Technical Service Bulletin: TSB140063

Cylinder Head Gasket Exhaust Side Coolant Orifices Misaligned with Cylinder Block Passages

Figure 1, New Cylinder Head Gasket on Cylinder Block

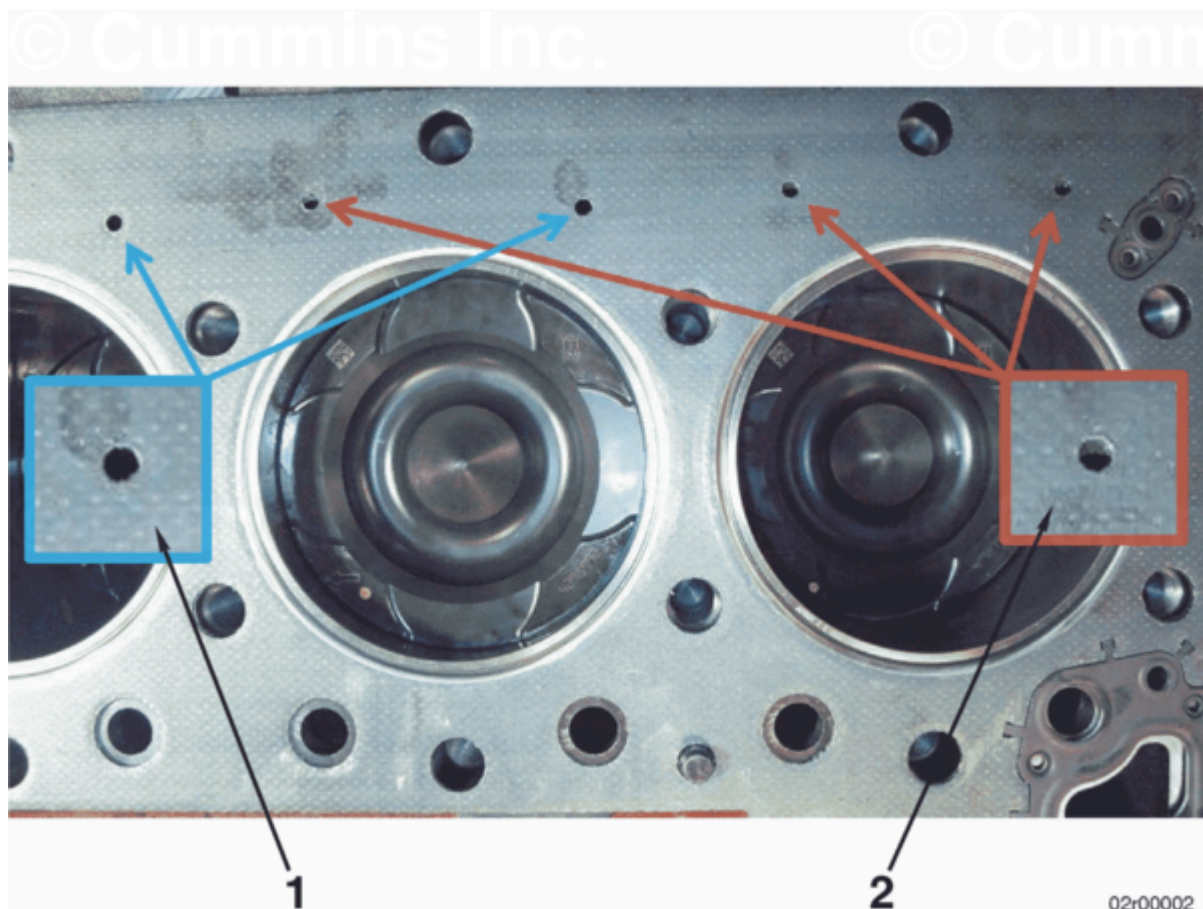
Heavy duty cylinder head gaskets with Part Number 4299098 have 12 orifices on the exhaust side of the engine that are primarily used for venting the cooling system. Some gaskets have the potential for three of these orifices to be misaligned with the coolant passages in the cylinder block.

With the cylinder head gasket located on the cylinder block, misaligned orifices will be identifiable near cylinders 5 and 6 (reference Figure 1).

New cylinder head gaskets identified with misaligned orifices in these locations are fit for service and should be used, **not** scrapped.

Gaskets removed from service are **not** considered failed or defective as a result of misaligned orifices observed in these locations.
